Request of Class II Permissive Change

Company name Kieback&Peter GmbH Co. KG
FCC ID: NY3RBW322MES
FCC Part 15 Certification

This is to request a Class II Permissive Change for FCC ID: NY3RBW322MES originally granted on 01/21/2015

Change 1: Hardware placement variation

RBW322-FTL-902 with Setting knob (Pos. 1)

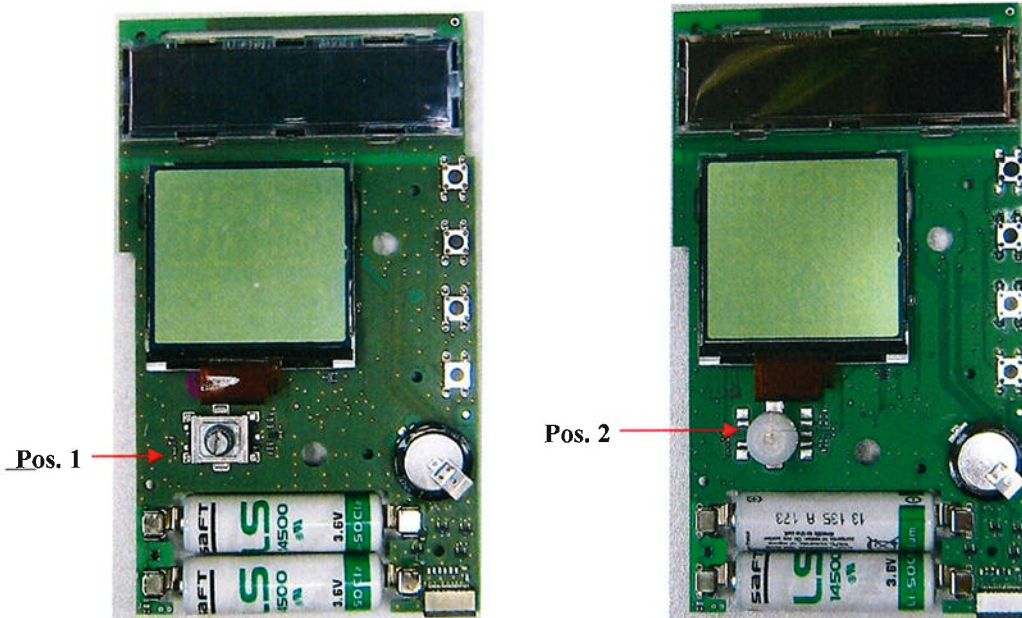
Both devices use the same PCB 66735001, placement variation.

RPW301-FTL-902 with PIR, Passiv Infrared Motion Sensor (Pos. 2)

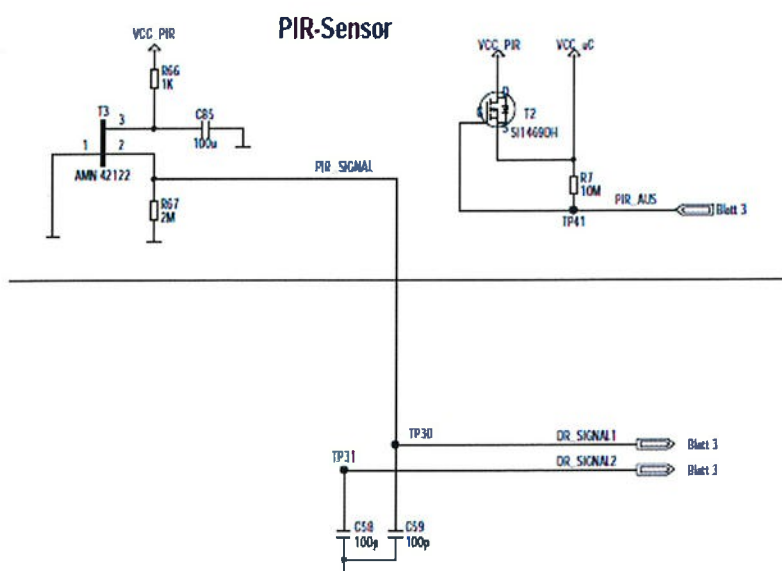
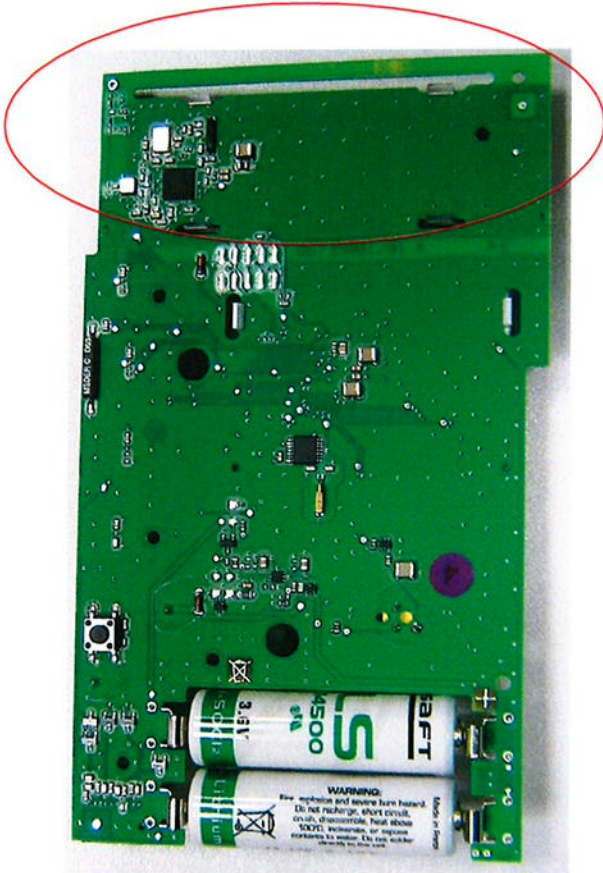
RBW322-FTL-902

RPW301-FTL-902

No change in radio Hardware and parameters
